September 22, 2021

# FINAL EVALUATION OF 2021 WILDFIRE MITIGATION PLAN UPDATE

# PACIFIC GAS AND ELECTRIC

*Figure 4.2.a: Overview of total WMP spend across utilities, territory-wide spend.*

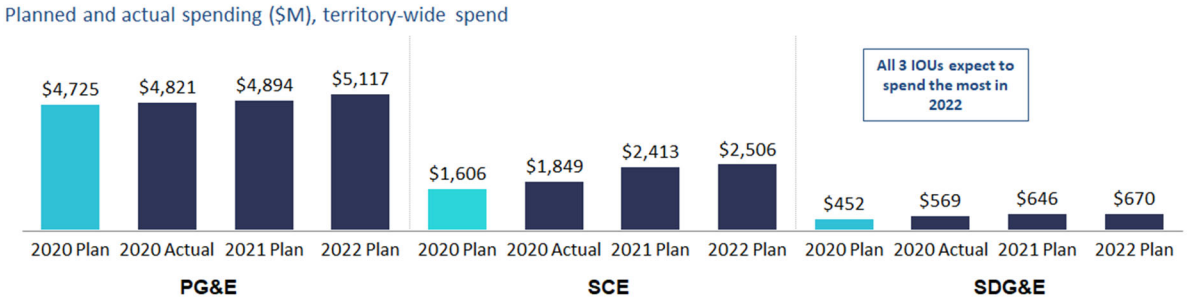
As Figure 4.2.a shows, PG&E has the highest spend of the three large electrical utilities but is significantly lower than SDG&E in terms of spend per circuit mile.

*Figure 4.2.b: Overview of total WMP spend across utilities, HFTD-only spend.*

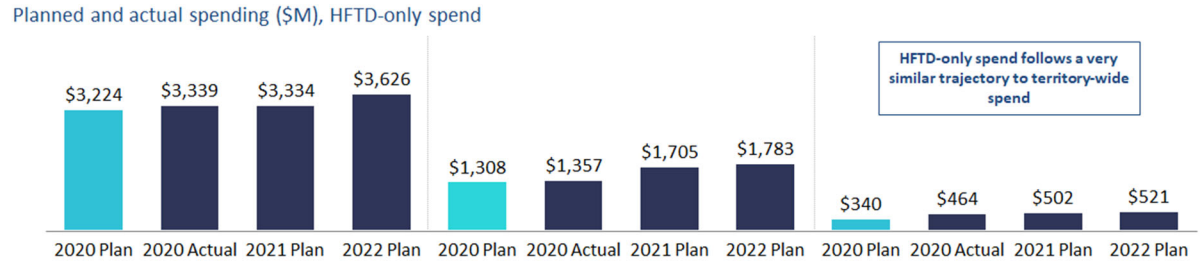
Figure 4.2.b provides a comparison of the high fire threat district actual and planned spends of the three large electrical utilities. As with total overhead circuits in Figure 4.2.a, PG&E's spend for HFTD circuit miles also falls between those of SCE and SDG&E.

*Figure 4.5.a: Number of ignitions per 10,000 RFW circuit mile days, IOUs.*

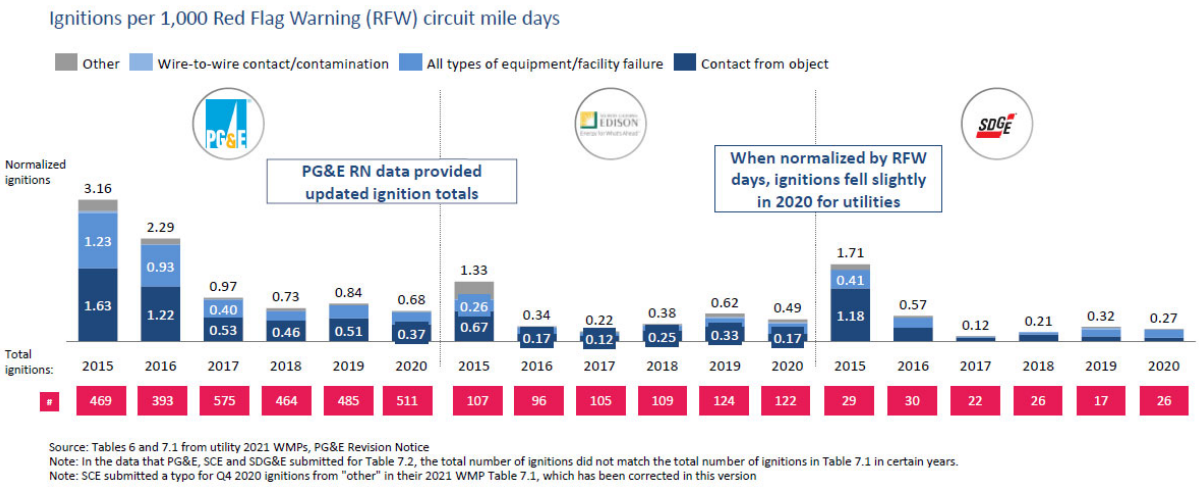
PG&E generally has more ignitions per overhead circuit mile compared to SCE and SDG&E (Figure 4.5.a). However, when normalized by RFW days, ignitions were reduced in 2020 for PG&E, SCE, and SDG&E. Ignitions are generally dominated by contact from objects, with equipment failure also representing a considerable fraction.

*Figure 4.5.b: Risk events per overhead circuit mile, including ignitions, IOUs.*

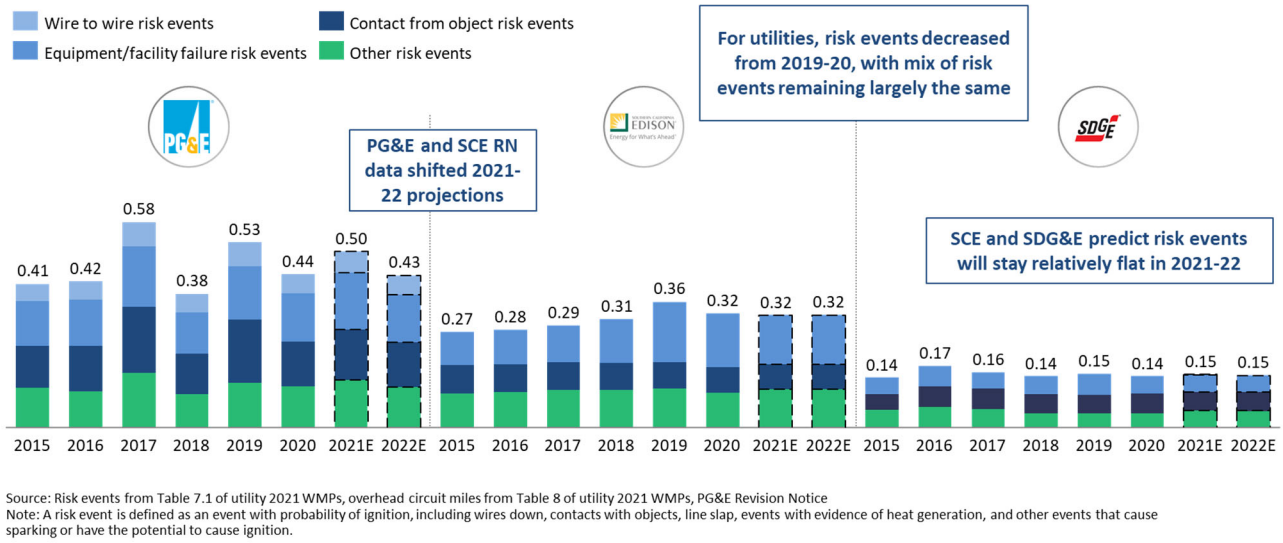
PG&E has the most risk events per overhead circuit mile, including ignitions (Figure 4.5.b) compared to SCE and SDG&E. PG&E projects a rise in risk event frequency in 2021, but then a slight decline in 2022. Consistent with this trend, PG&E experiences both more Red Flag Warning overhead circuit mile days per year than SCE and SDG&E do (Figure 4.5.c) as well as a greater percentage of increase from 2019 to 2020.

*Figure 4.5.d: Asset inspection findings per circuit mile inspected, IOUs.*

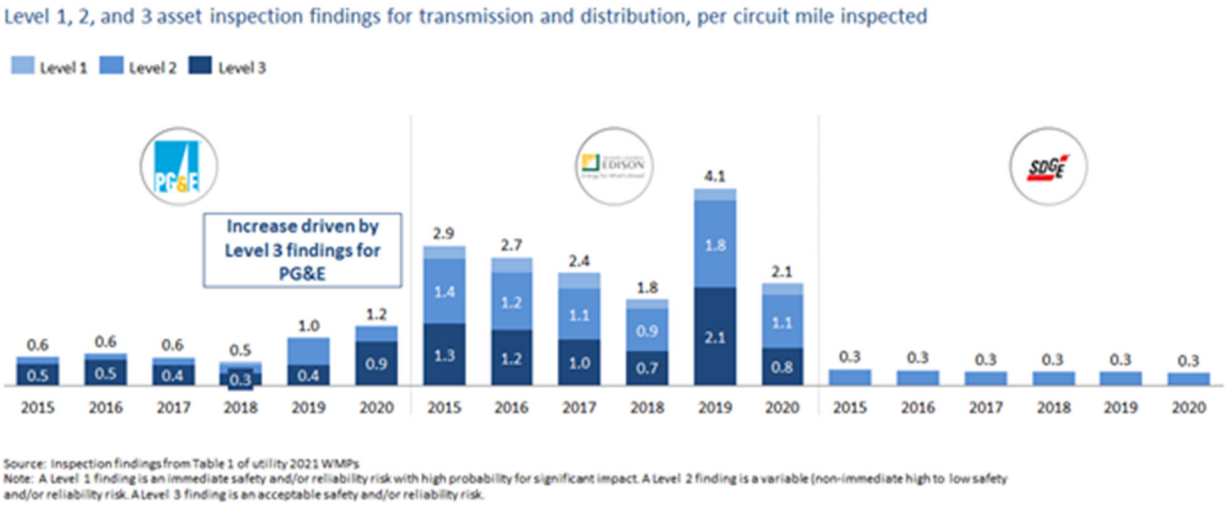
SCE has considerably more asset inspection findings than either PG&E or SDG&E (Figure 4.5.d). PG&E findings increased in 2019 and 2020 due to an increase in Level 3 findings but remain well below SCE findings.

*Figure 5.7.a: Data governance maturity score progress.*

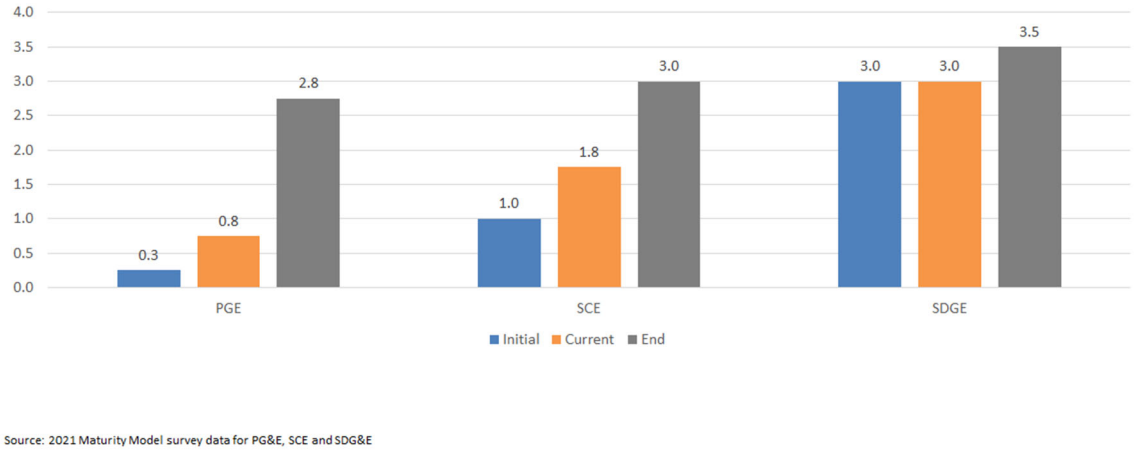
As noted in Figure 5.7.a, PG&E shows significant progression in their data governance maturity score, however, it remains behind both SCE and SDG&E in this area.

*Figure 5.7.b: Data governance spend per HFTD overhead circuit mile, large utilities 2020-2022.*

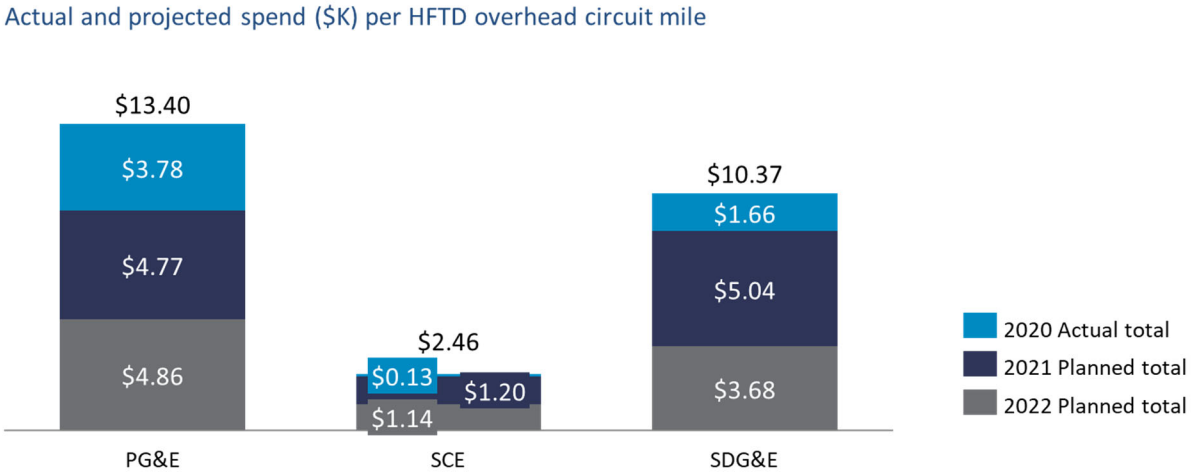
As Figure 5.7.b shows, PG&E is spending more per HFTD overhead circuit mile on data governance than either SCE or SDG&E.
